TRANSPOWER

Summary and response to consultation submissions

Huntly–Ōtāhuhu A reconductoring BOB–DRY and HLY–T43 sections

August 2026

Figure 1: Outage planning for HLY–BOB–DRY circuit 1&2

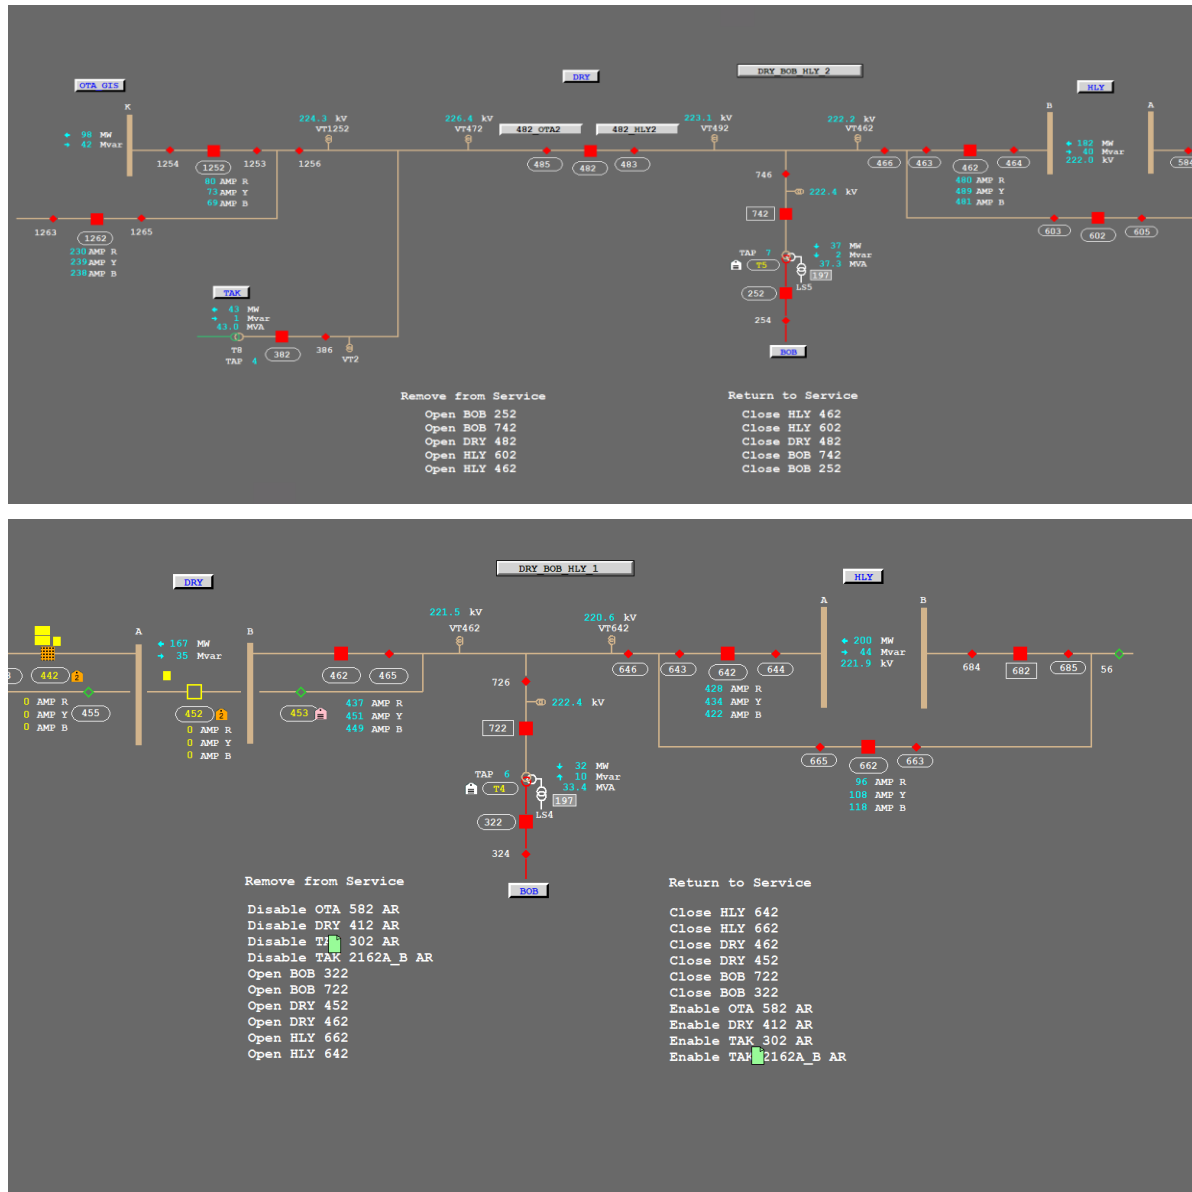
Genesis also sought clarification on how the works would be delivered. It noted its understanding that, during construction, the isolation point would allow Huntly Unit 5 to remain connected to both the A and B buses.

Transpower's response: We welcome Genesis's support for the preferred option. The specific isolation arrangements described in Genesis's submission are not currently proposed by Transpower. However through alternative arrangements outlined below, Huntly Unit 5 is expected to be able to remain connected to both Bus A and Bus B during the works.

- For HLY–BOB–DRY circuit 1, the proposed isolation points are circuit breakers 642 and 662.
- For HLY–BOB–DRY circuit 2, the proposed isolation points are circuit breakers 462 and 602.
